**Memorandum**  
**Planning and Urban Development Department**  
**Planning Division**

Date: January 19, 2018

Re: MMC East tower and Visitor Garage Vertical Expansion  
 22 Bramhall Street  
 Maine Medical Center (MMC)

Project #: 2017-289 CBL: 053D007/054H001/064C001

*Rendering as viewed from east ( Ellsworth Street) showing secondary helipad (see WS Q – 1 which includes additional renderings & before/after comparisons)*

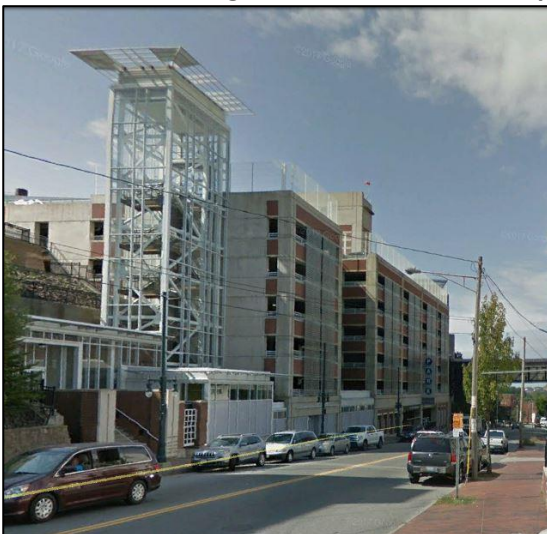
<p><b>Maximum Building Height:</b> East Tower: 150 feet (the IDP indicated a future height of 141 ft including helipad)</p>	<p>Submitted proposals indicate a height of just over 146 ft but part of the helipad appears to be higher</p>	<p>Clarification required as to helipad height compared to the average grades identified in the IDP.</p>
<p><b>Maximum Building Height:</b> Visitors Garage: 125 feet (the IDP indicated a future height of 119 ft)</p>	<p>Submitted proposals indicate a height of 119 ft excluding part of the stair tower</p>	<p>Appears to meet dimensional requirements as stair and elevator overruns are considered appurtenances.</p>
<p><b>Transition Zones</b> – none at these locations</p>	<p>N/A</p>	<p>N/A</p>
<p><b>Setbacks:</b> East Tower - 20 ft Visitors Garage - up to 40 ft</p>	<p>N/A</p>	<p>N/A</p>
